Final Environmental Statement

related to license renewal
and power increase for the
National Bureau of Standards Reactor

Docket No. 50-184

NUREG-0877

Figure 4.2 Location of water sampling sites

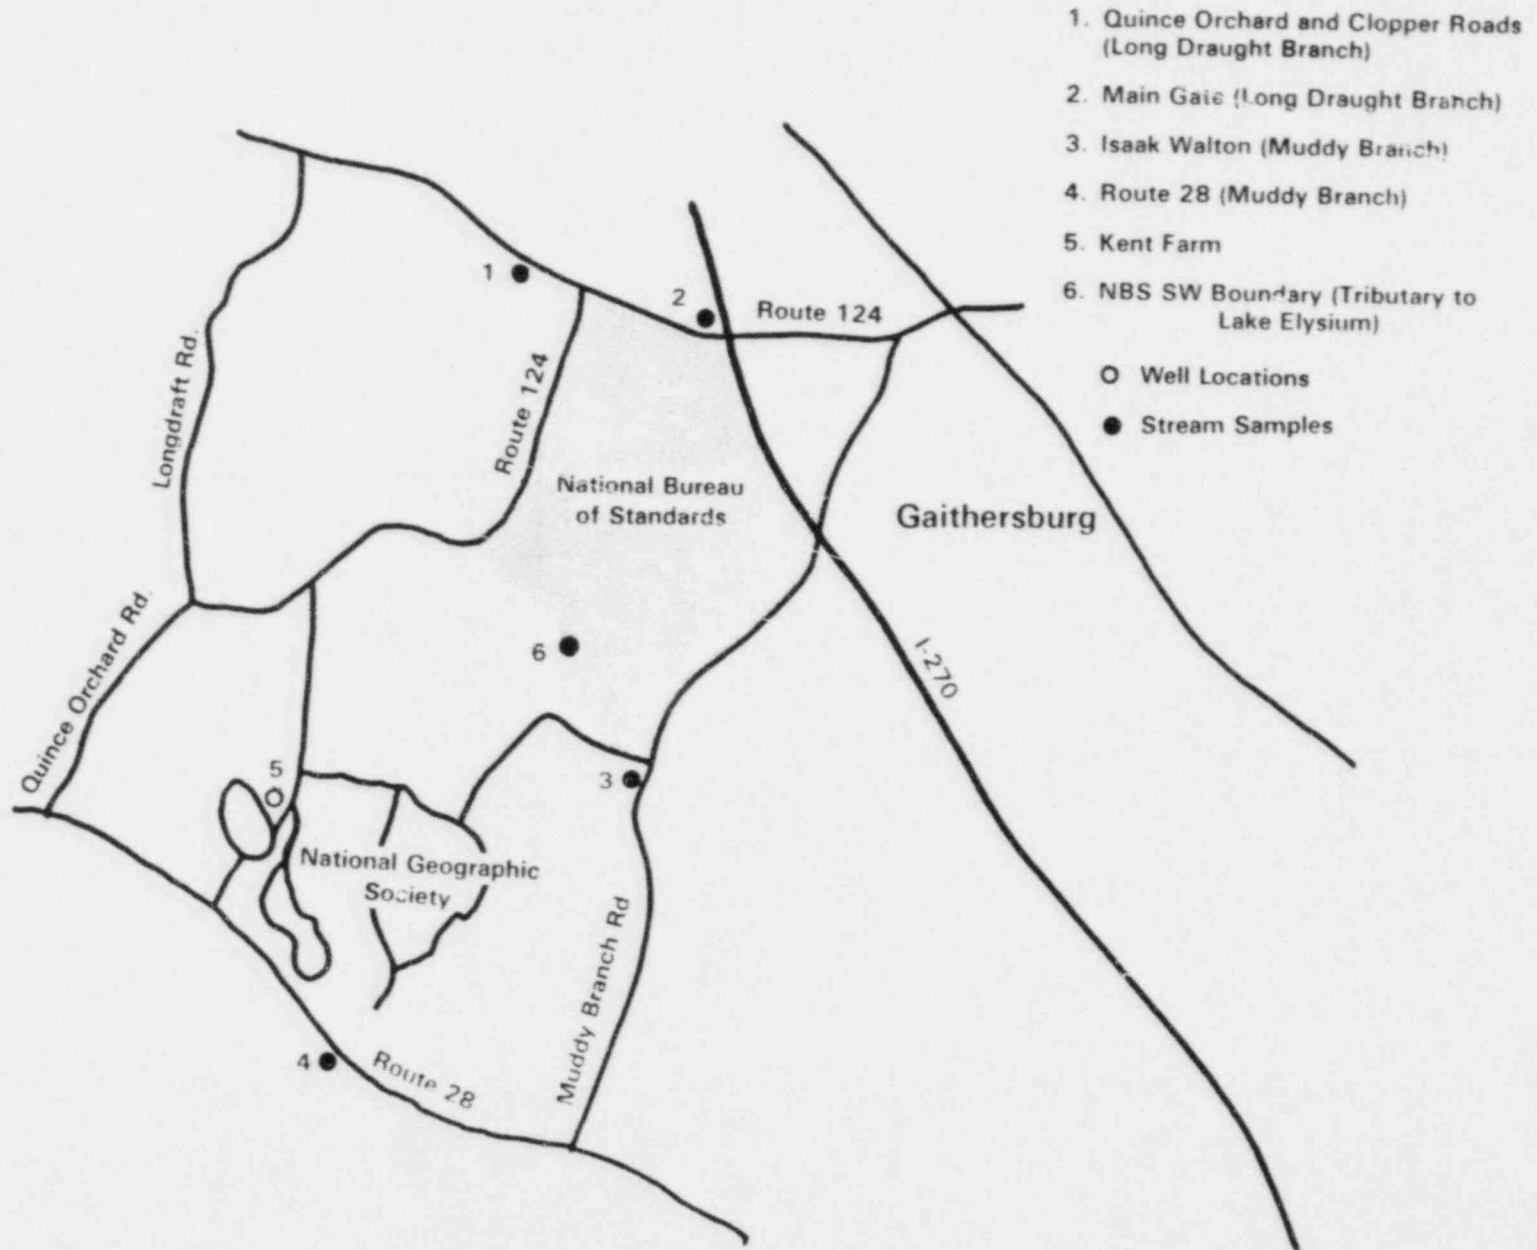
The streams sampled in the environmental monitoring program should be named and shown on figure 4.2. Consideration should be given to including Lake Elysium, downstream from the reactor on the Muddy Branch tributary that drains the reactor site, in the sampling program.

Consideration has been given to including Lake Elysium in the environmental monitoring program. However, the large volume of water in lakes makes them less sensitive to change, and lakes tend to have a higher radiation background than streams. Therefore, instead of sampling Lake Elysium itself, the water sampling program has been extended to include sampling upstream from Lake Elysium at the point where the stream leaves the NBS grounds in the vicinity of the reactor. Figure 4.2, "Location of Water Sampling Sites," has been revised to show the additional sampling location and the names of the streams being sampled.
